2190947

Response to Request for Information Powerhouse Parramatta – SSD 10416

To	WMA DPIE	18 January 2021
Copies	Tom Kennedy	Reference number
From	ARUP	File reference Tech Note 3000
Subject	Powerhouse Parramatta – DPIE Flood RFI's

Figure 1 – Plan and Section of Retaining Wall Adjacent to 330 Church Street

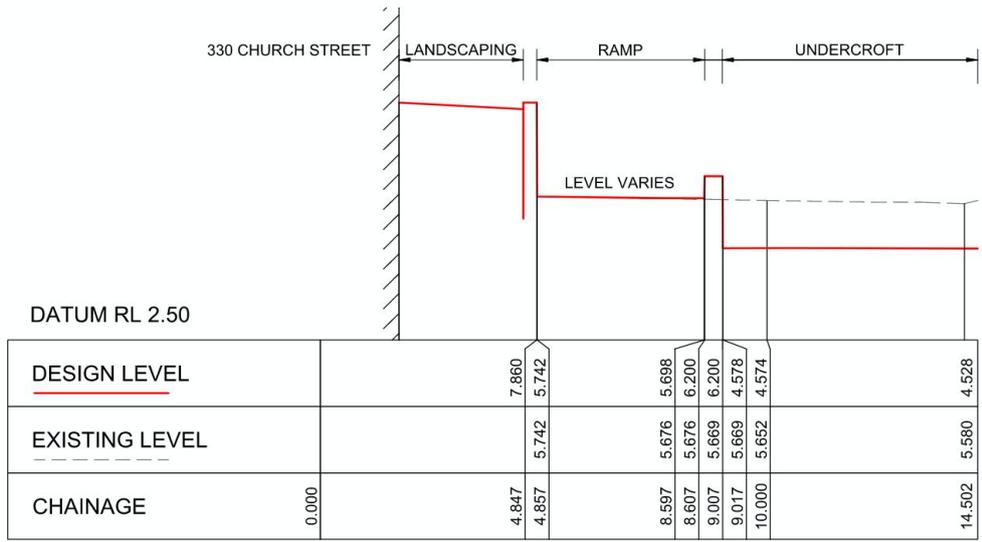
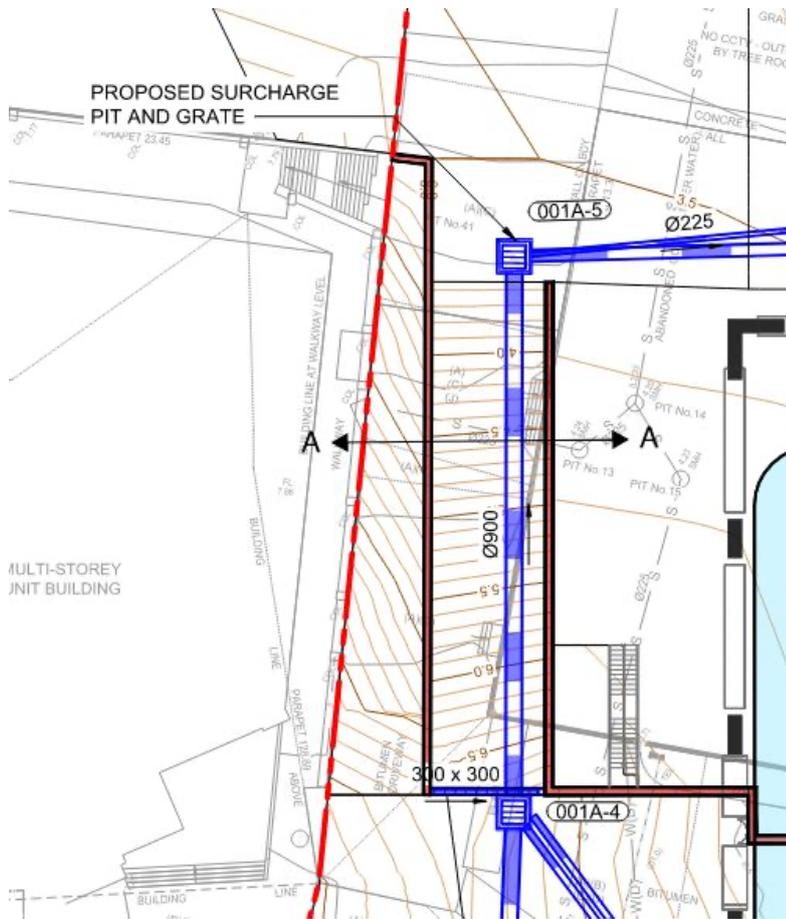
2.4 Mitigation Measures for 330 Church Street

Section 7.3.3 of the Flood Risk and Stormwater Management Addendum report makes reference to a feasible mitigation measure that results in there being no adverse flood impact, in the 1% AEP event excluding climate change, to 330 Church Street.

A retaining wall is to be provided to support the ramp connecting the southern end of Dirrabarri Lane to the Parramatta River foreshore. The top of the retaining wall supporting the west end of the ramp, wraps around to the corner of 330 Church Street. The top of the wall has been set at the 1% AEP flood level meaning that flood waters can't overtop and inundate the basement car park in events up to and including the 1% AEP event. The top of wall height could be increased to meet the levels for the 1% AEP flood level with climate change if the consent authority deemed this to be necessary.

Refer to Figure 1 for extracts of the civil design showing the general arrangement of the wall and a typical section.

Job No 273467	Figure Status Final
Figure No P1.10-0.10A-MOF	Issue 1

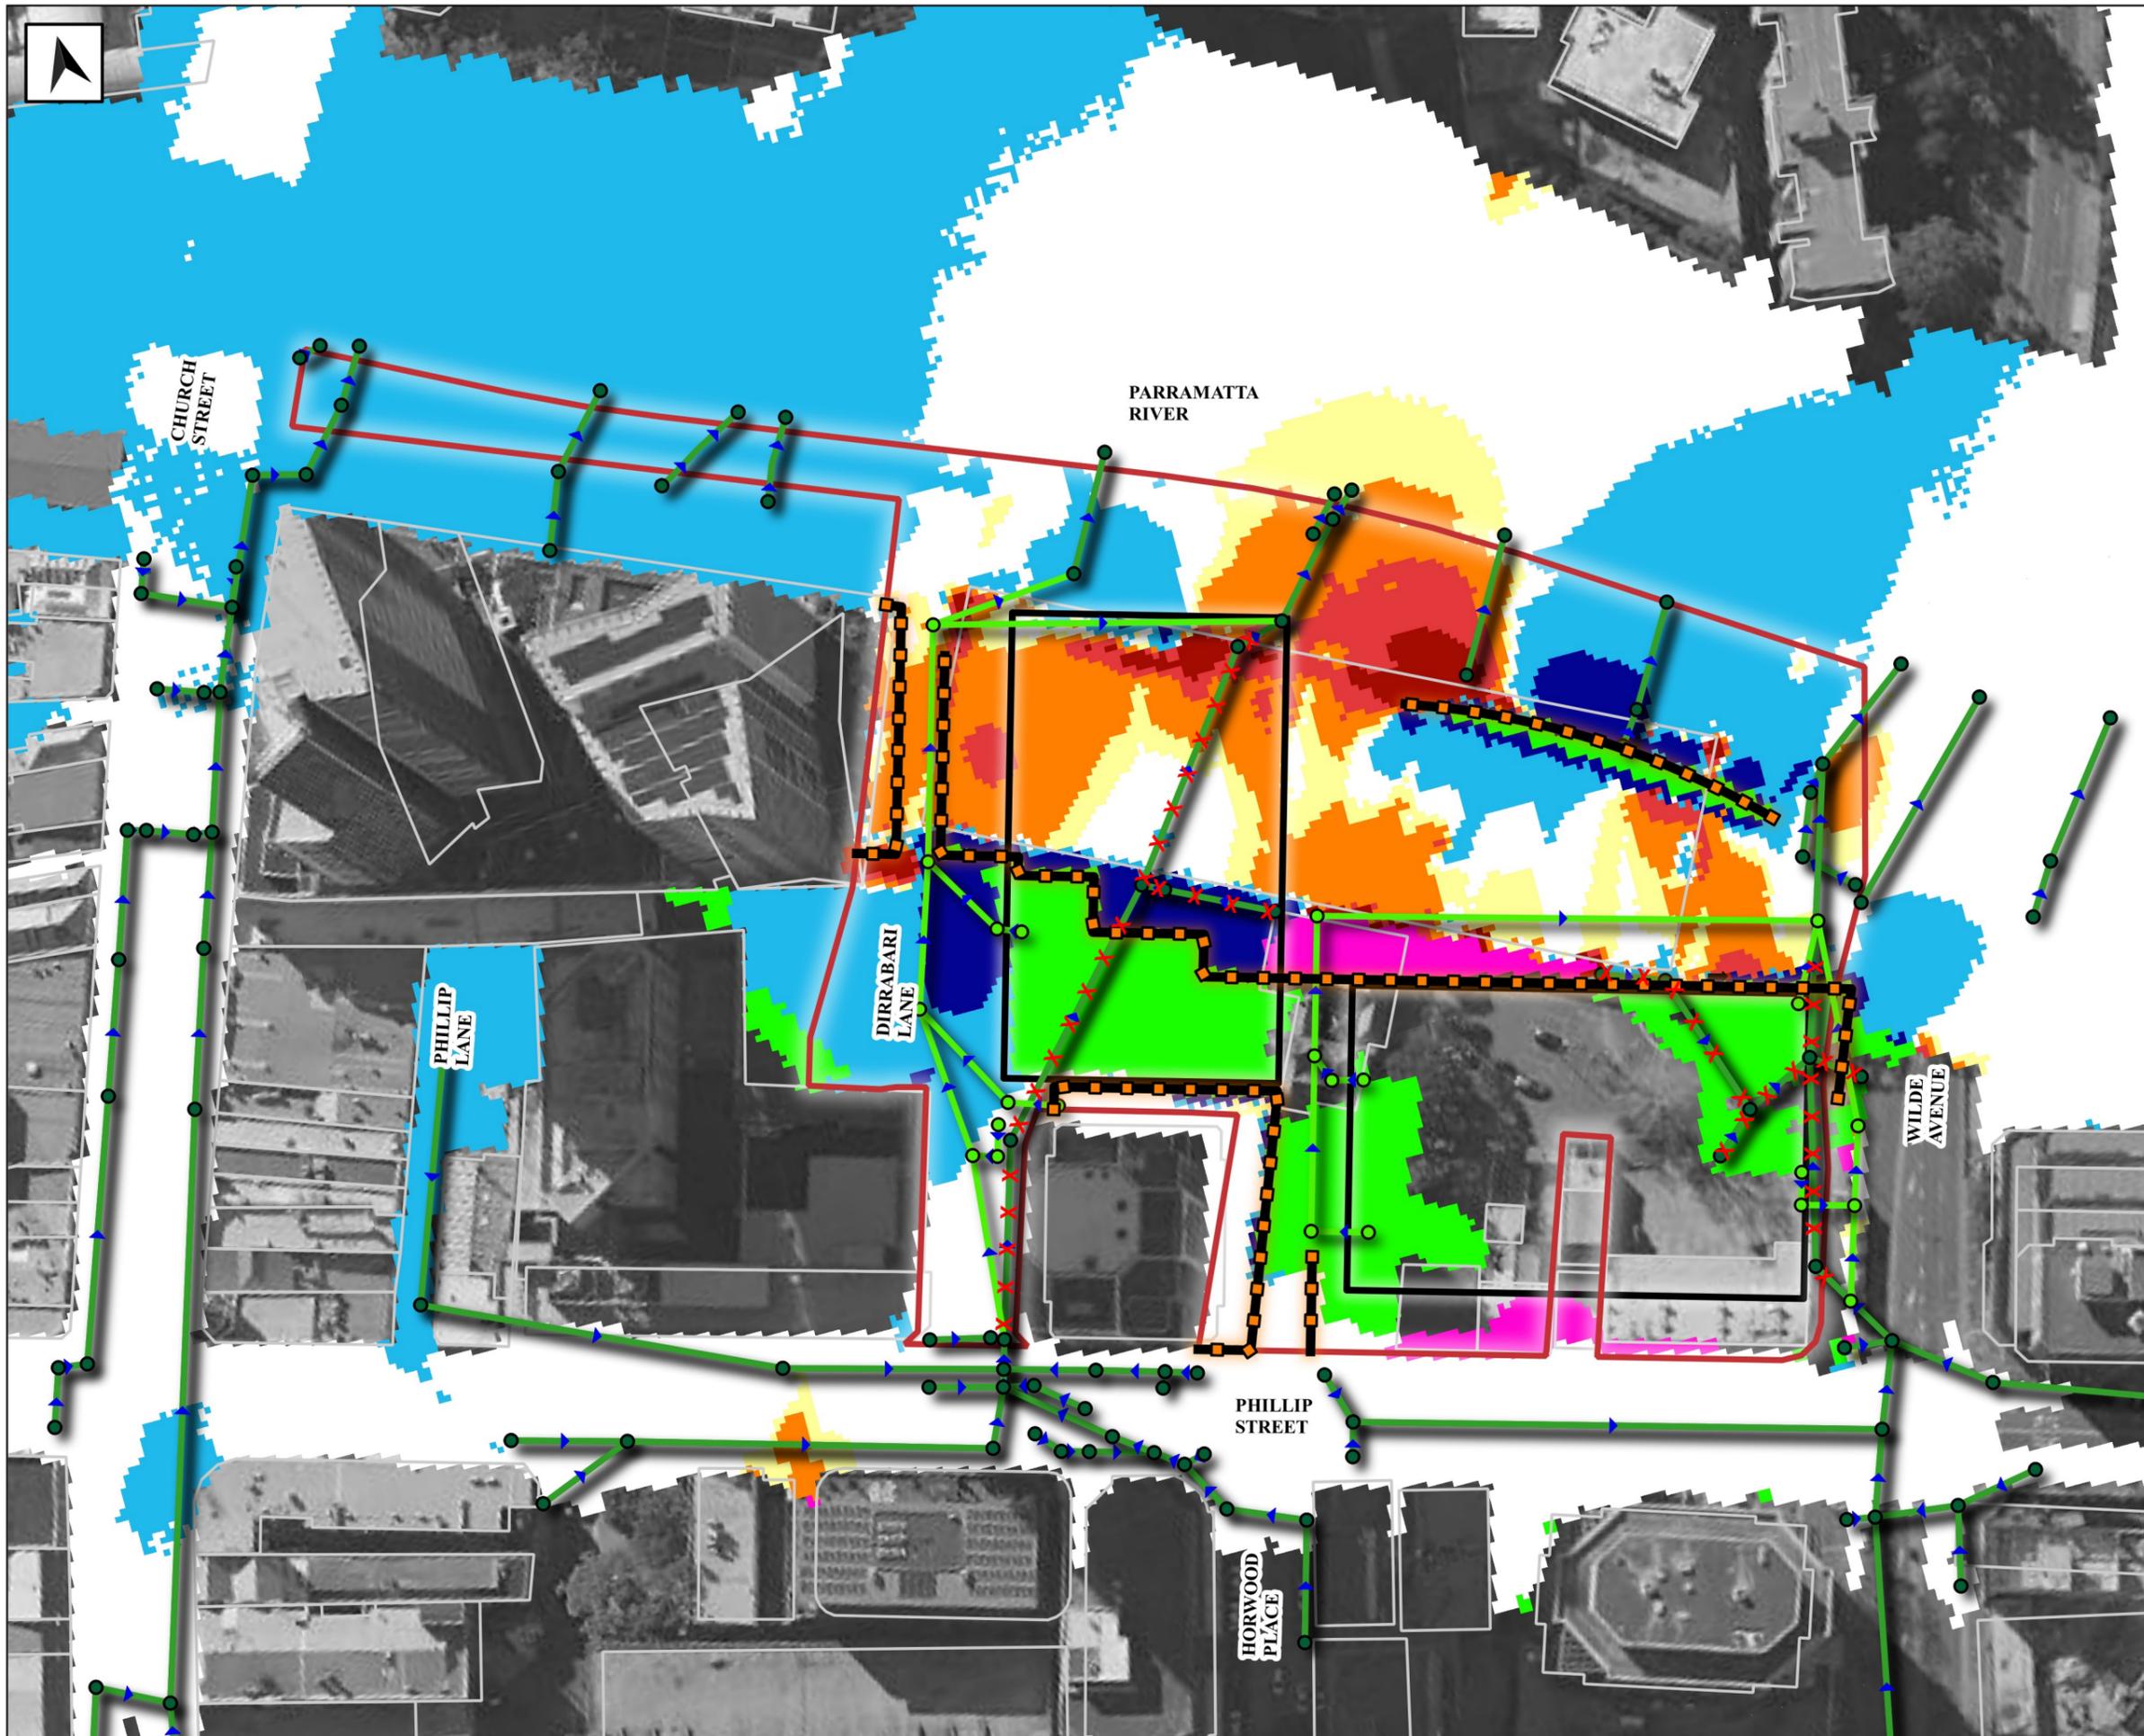
2.1 Impact of Filling of land above 1:100 Average Recurrence Interval and up to the PMF

The reporting to date has focussed on flood impacts up to and including the 1% AEP flood. To understand the magnitude of impacts for rarer floods, impact maps are attached to this technical note for the 1:1000 AEP flood and the Probable Maximum Flood (PMF). These maps are presented in Figures P1.19-0.10A-MOF and P1.19-PMFA-MOF.

- Impacts for the 1:1000 AEP flood on private property outside the site are less than 10mm except for a few small areas. One is adjacent to 330 Church St and another is a small area in Phillip St (which is likely to be due to modelling accuracy issues).
- Impacts for the PMF are less than 10mm for area along the Parramatta River. However, the project would result in impacts in the order of 50mm in the Parramatta CBD. Flood depths for the PMF in these streets would already be in the order of 2m to 4m.
